Addendum No. 3

RFT 25-055 - Washroom Renovation - Central Public School

CENTRAL PUBLIC SCHOOL WASHROOM AND STORAGE ROOM RENOVATIONS

ADDENDUM No. 3

project no. 2024-88

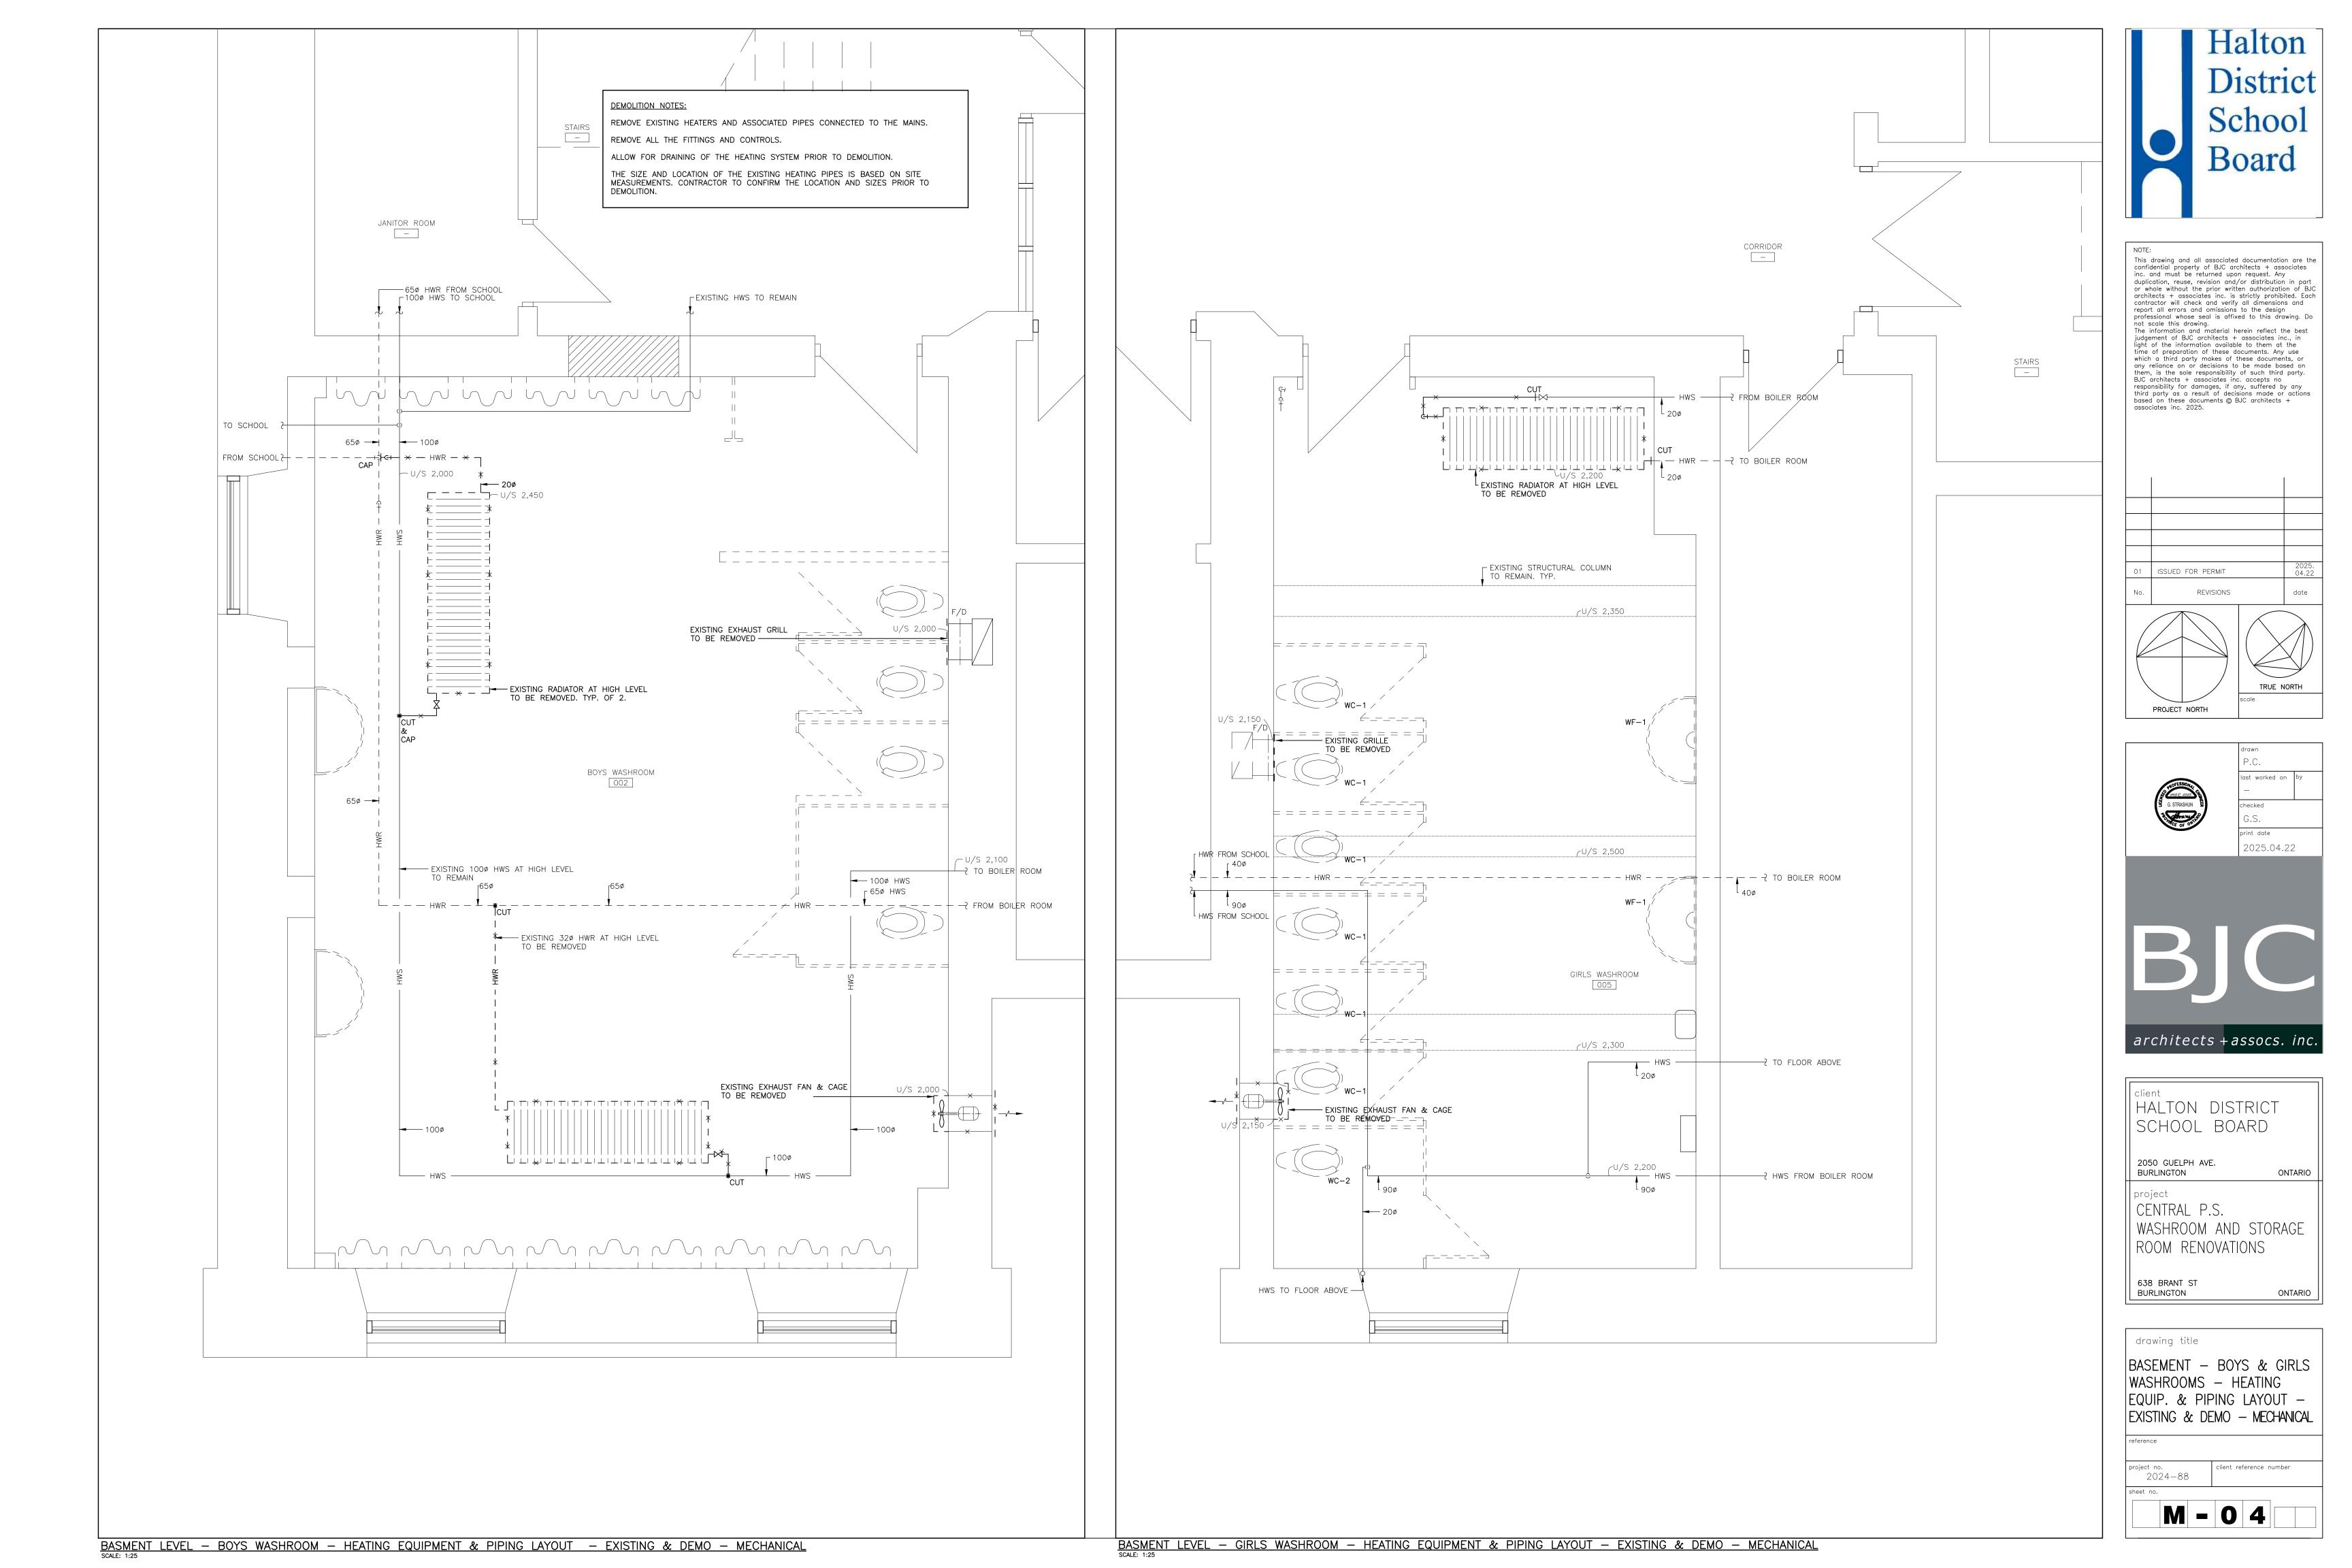
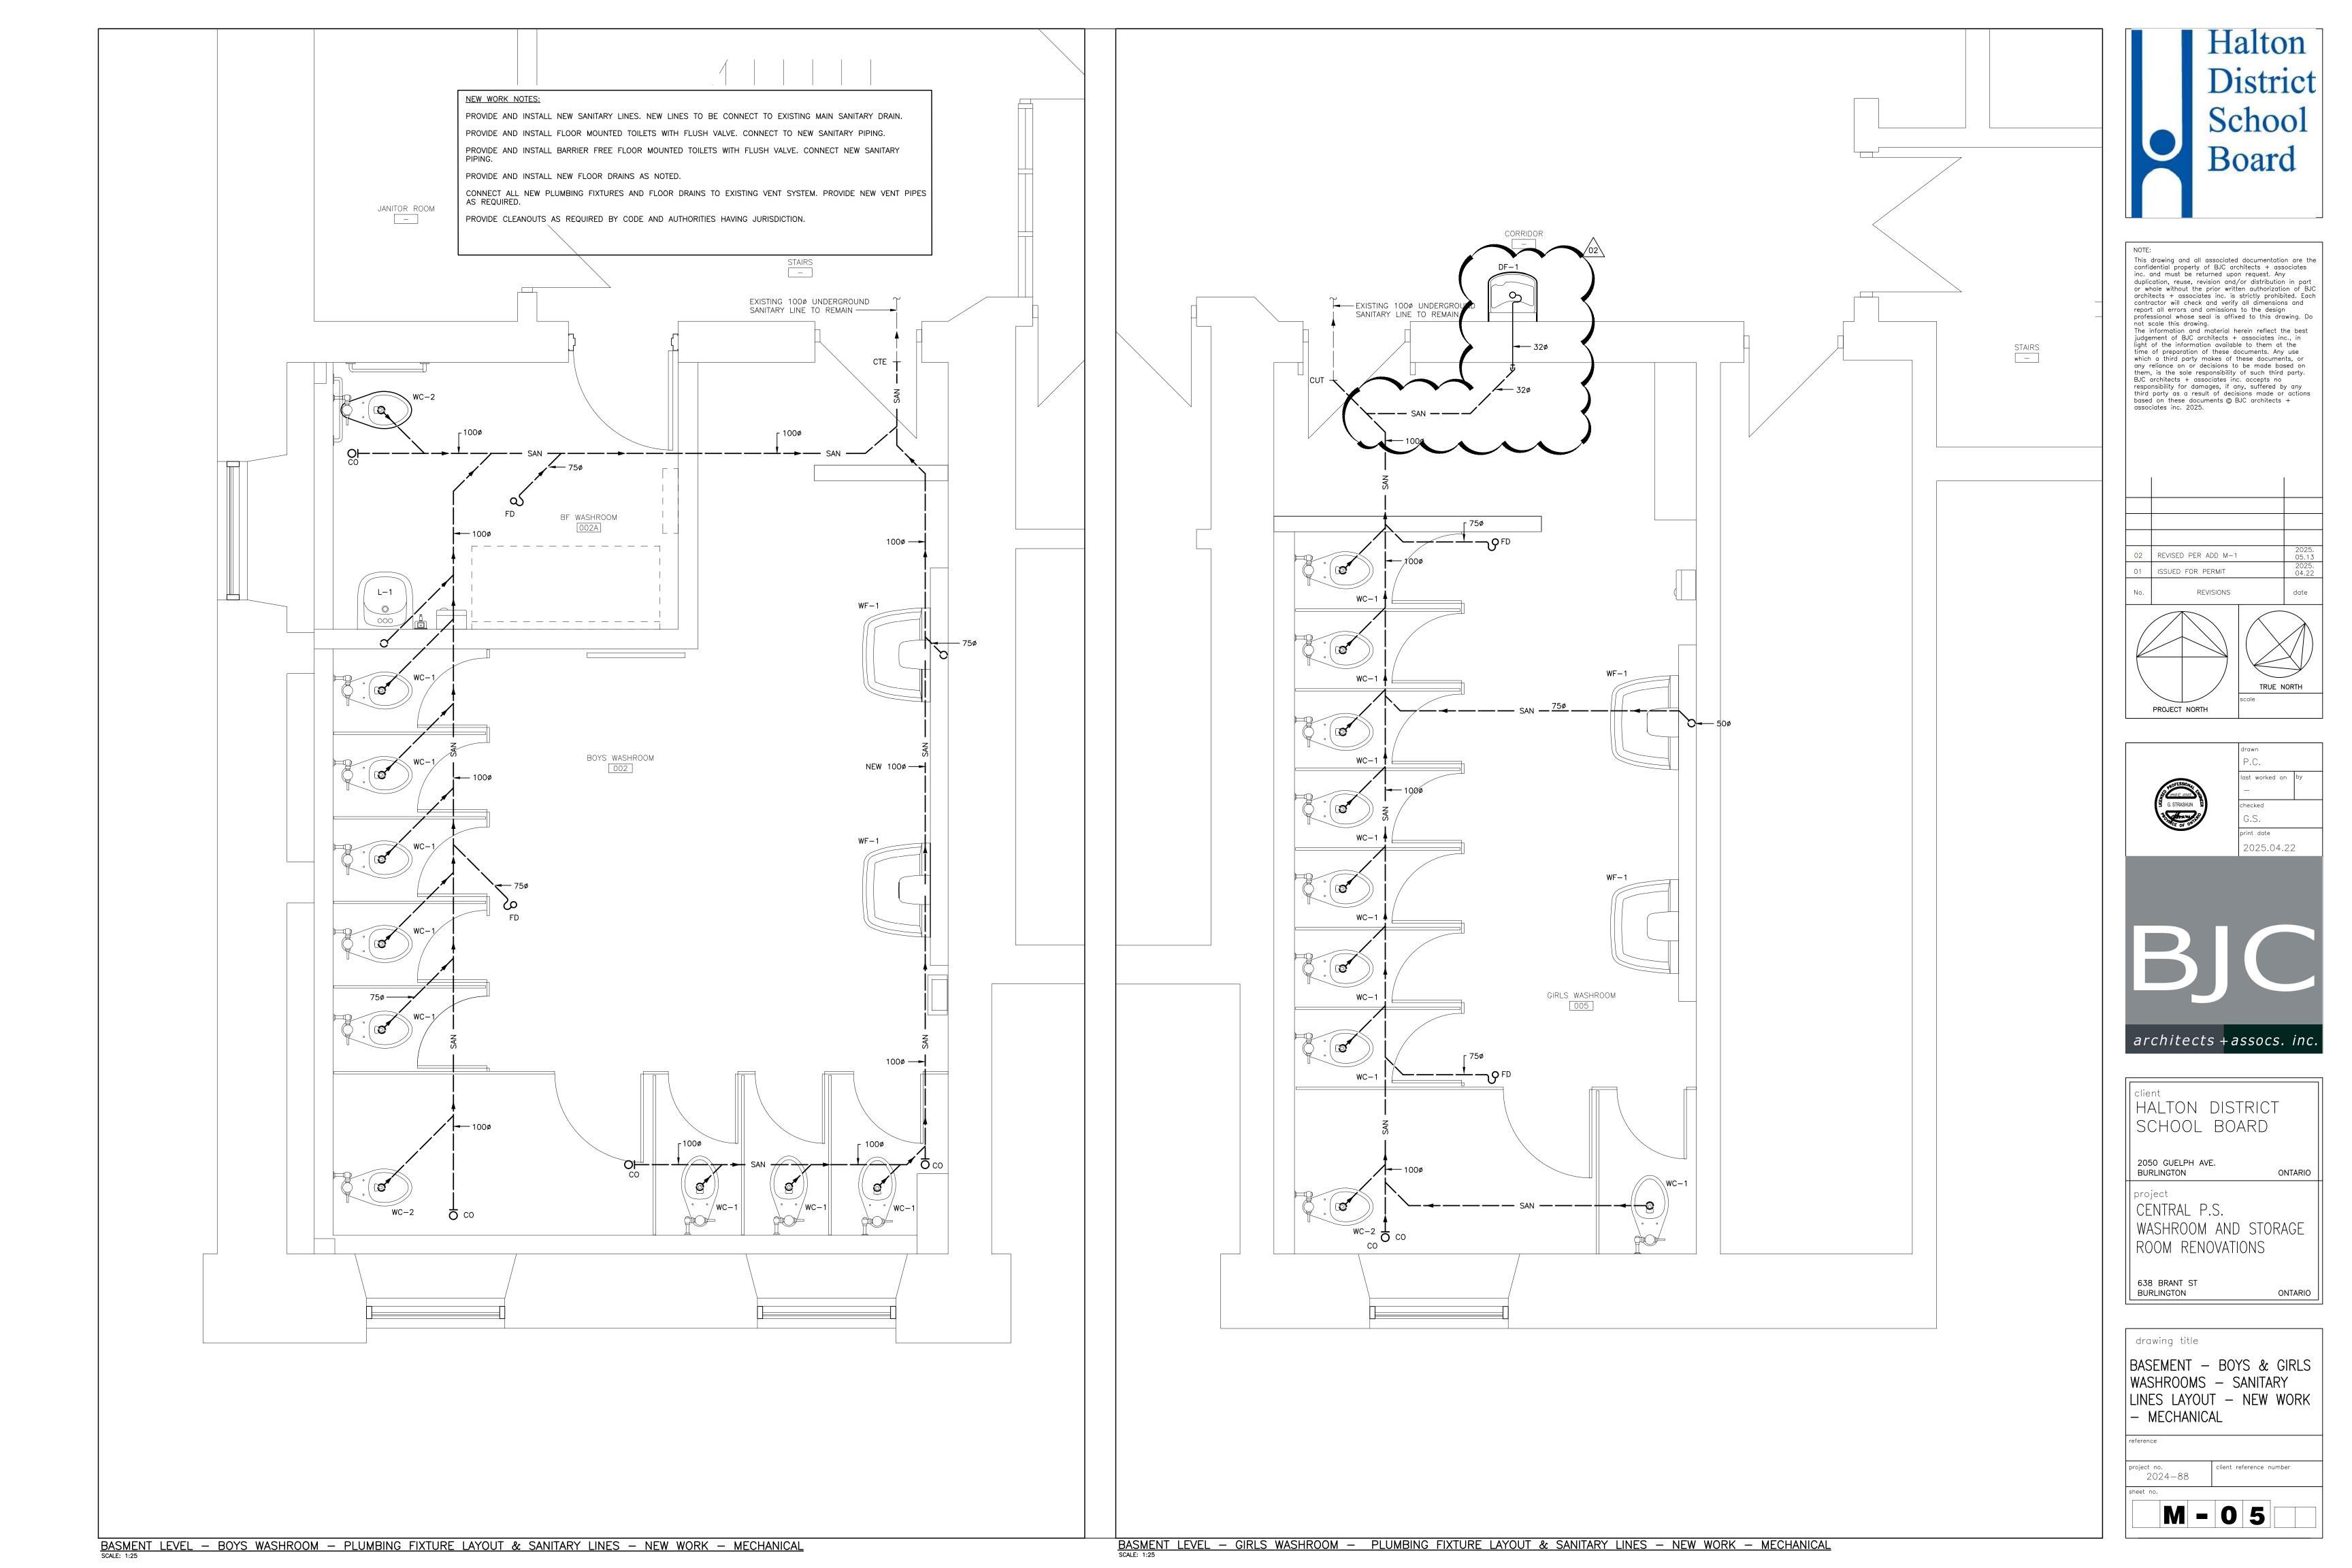
1.1 Refer to updated Mechanical drawings M-01 to M-07 attached to replace previously issued drawings M-01 to M-07.

3.1 Remove the existing drinking fountain and associated drain, vent and CW pipes located outside of Bous Washroom. Install new wash fountain as noted on the drawings. Connect to new drain, CW and vent pipes. Provide power supply for the new fountain as required by the manufacturer from the nearest available panel. The fountain to be water bottle filling station manufactured by Elkay model LZSG8WSLK, ADA approved, filtered water, refrigerated.

- 4.1 All the new HW heaters to be installed at high level.
- 4.2 Contractor to ensure that when removing any pneumatic controls, the tubes are maintained, cleaned and the existing system remains operational
